## LINCOLN PARK PLANNING COMMISSION

## 1519 Southfield – Taco Bell

### Site Plan Review

Applicant	Matt Yanda, GDP Group
Project	Taco Bell
Address	1519 Southfield Road, Lincoln Park, MI 48146
Date	December 9, 2020
Request	Site Plan Review
Recommendation	Approve with Conditions

**FRONT ELEVATION** 1/4" = 1'-0" **C**

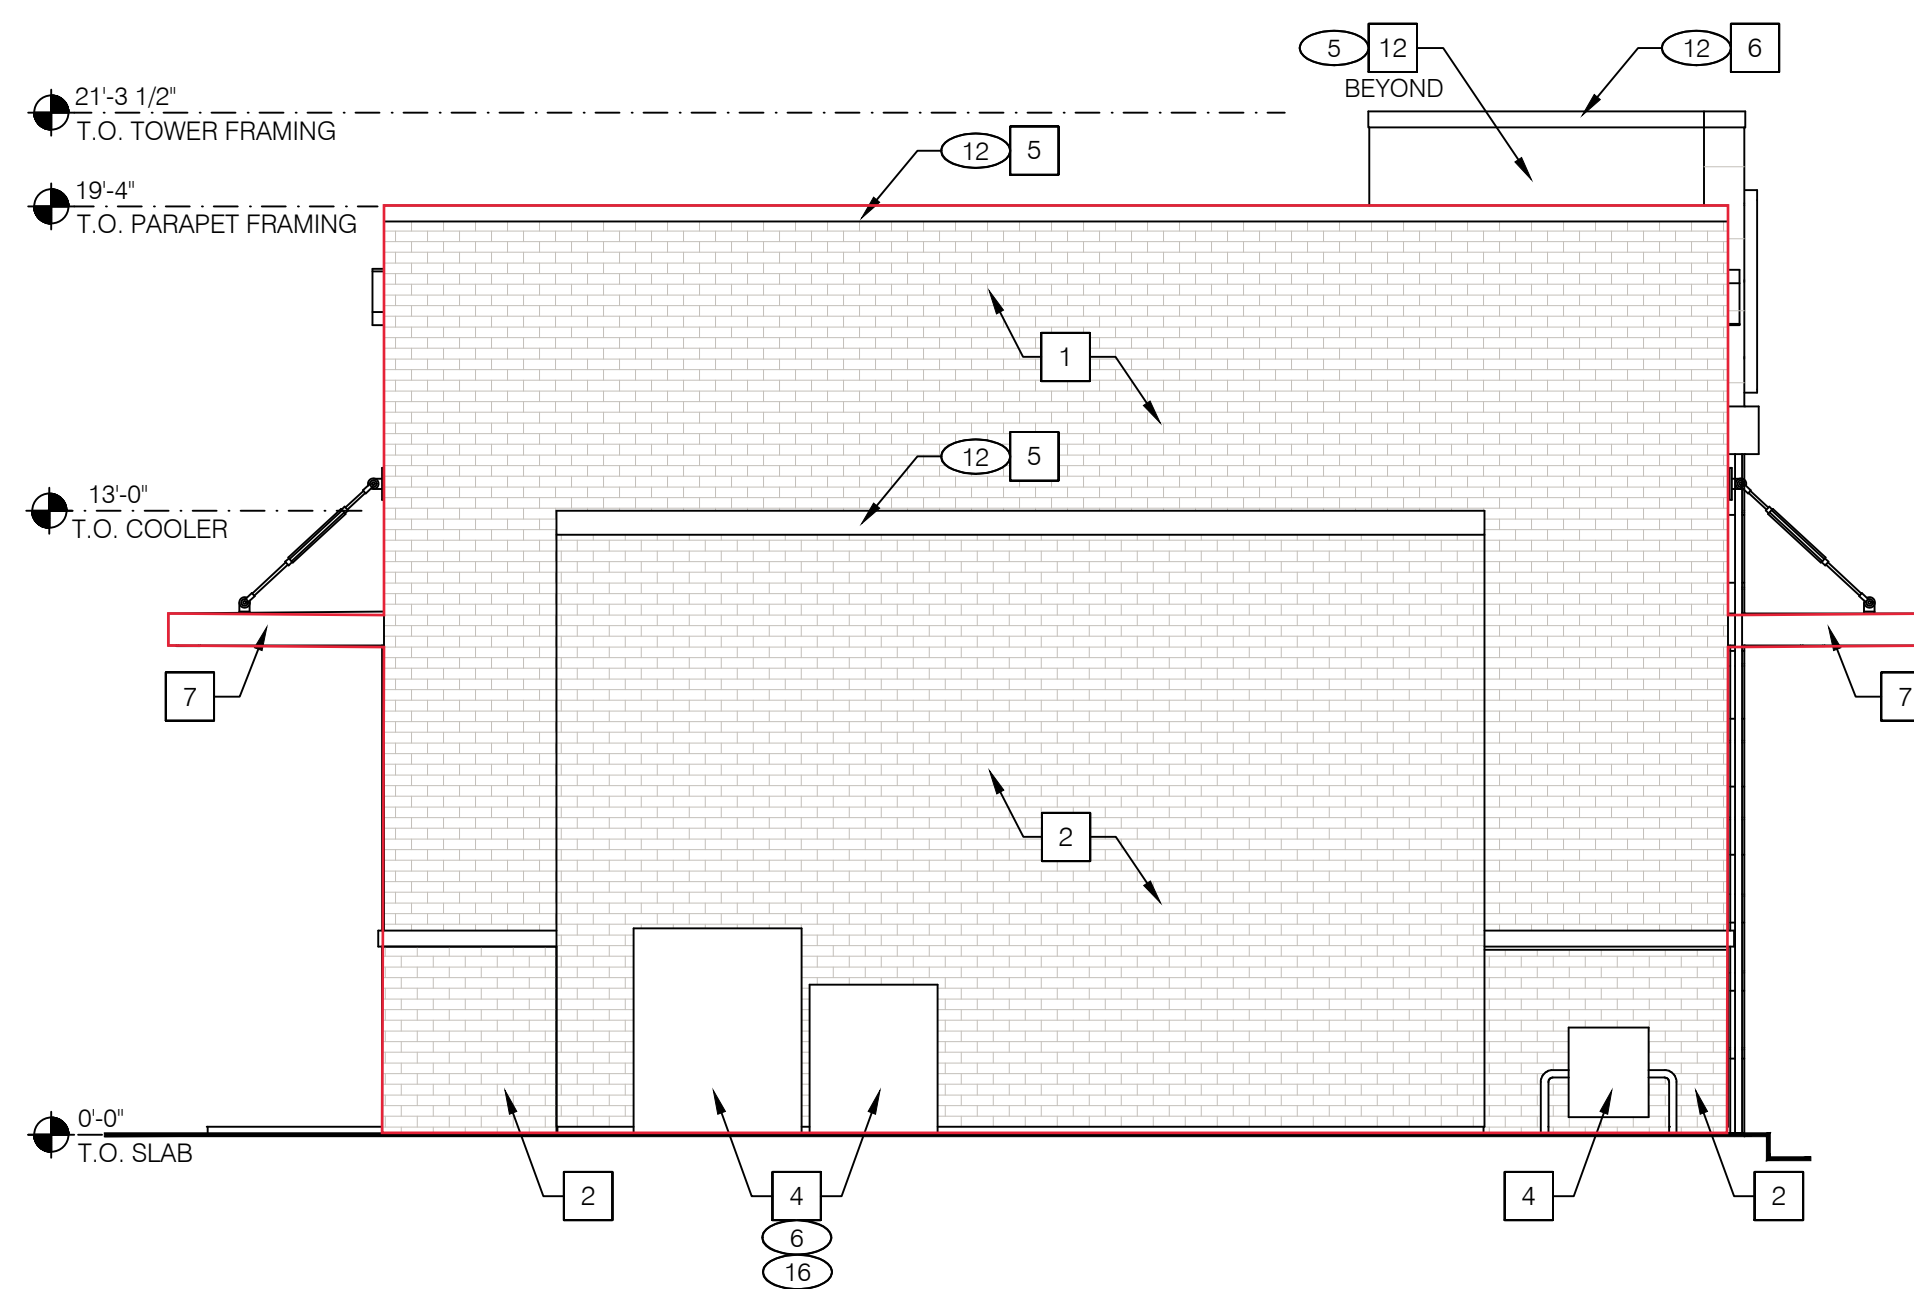
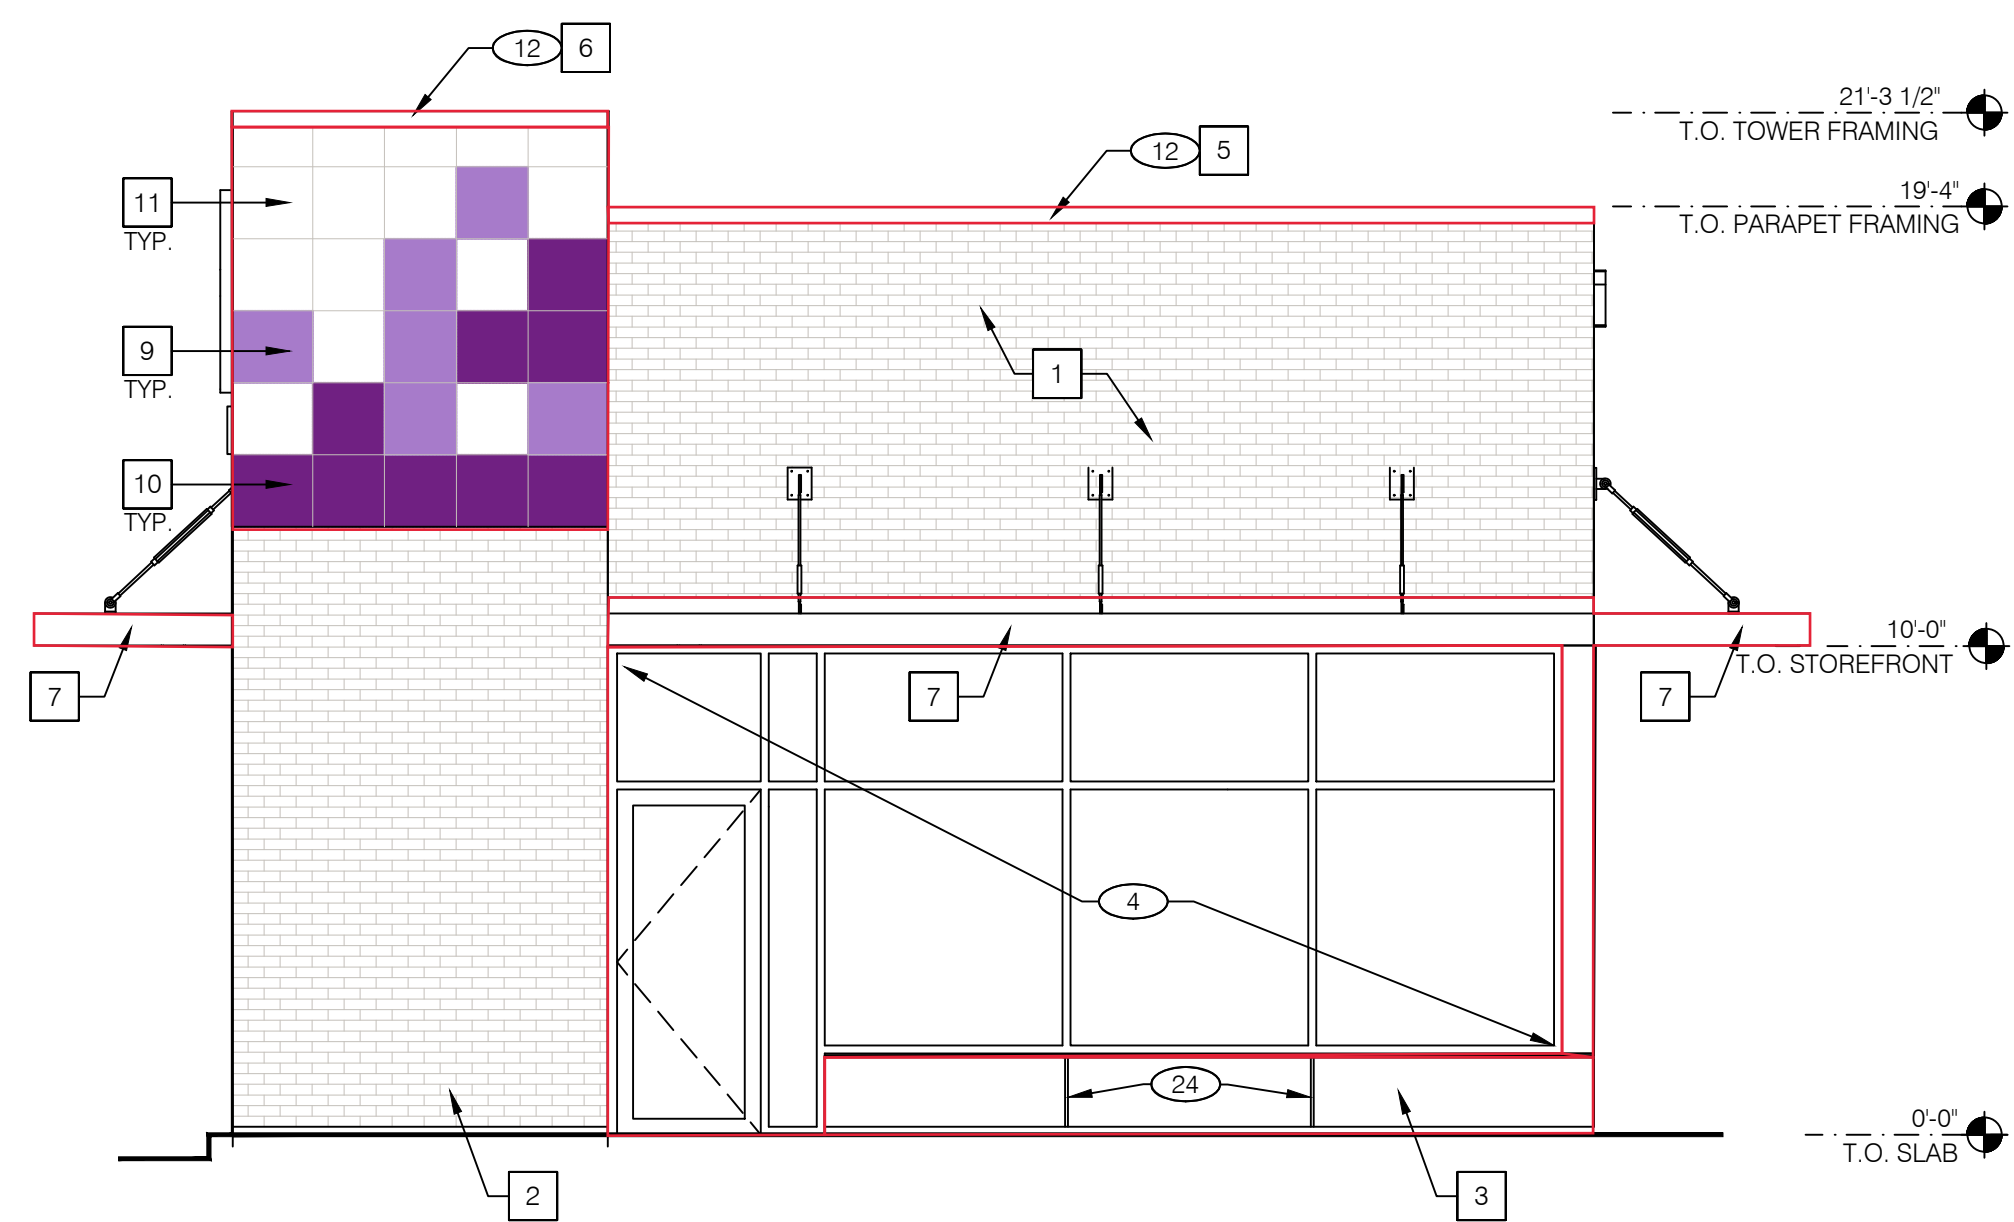
- Applicant shall revise front façade materials to comply with façade material percentage requirements.
- Applicant shall show roof-top mechanical equipment screening, if applicable.

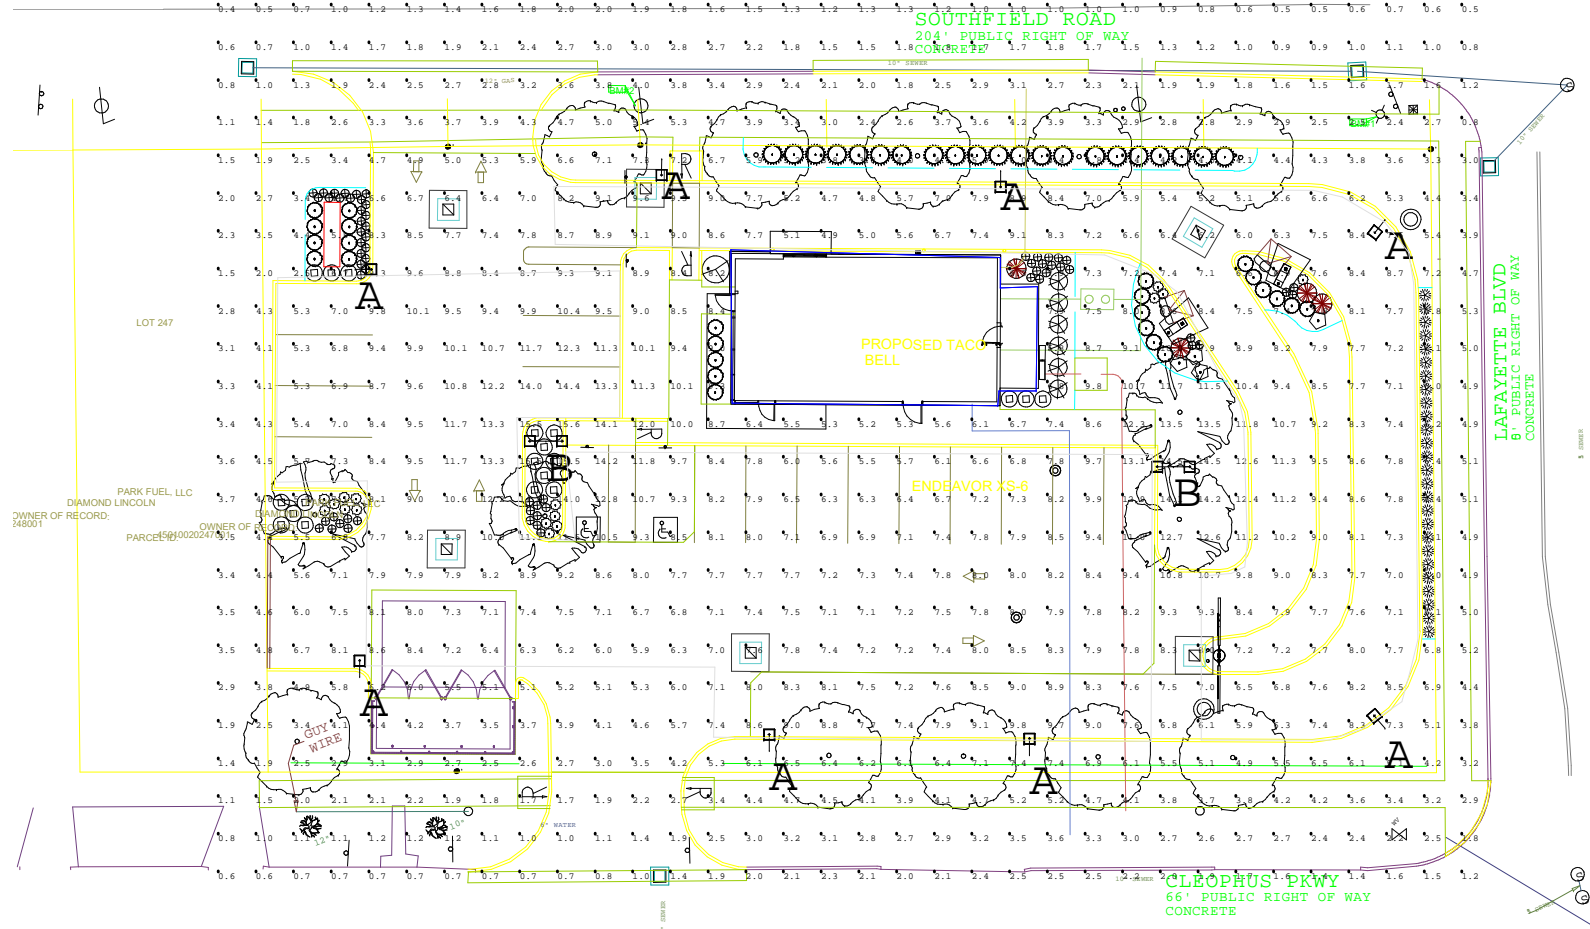
The Photometric Plan shows two proposed lighting fixtures, each 25 feet in height, though no specifications on fixture design are provided. The Plan provides a luminaire schedule, indicating that the plan shows measurements in lumens; however, the lighting requirements in section 1294.31(f) are in footcandles.

- Applicant shall provide manufacturer specifications and measurements in footcandles to ensure that lighting is arranged to deflect away from adjacent properties and so that it does not impede the vision of traffic along adjacent streets.*
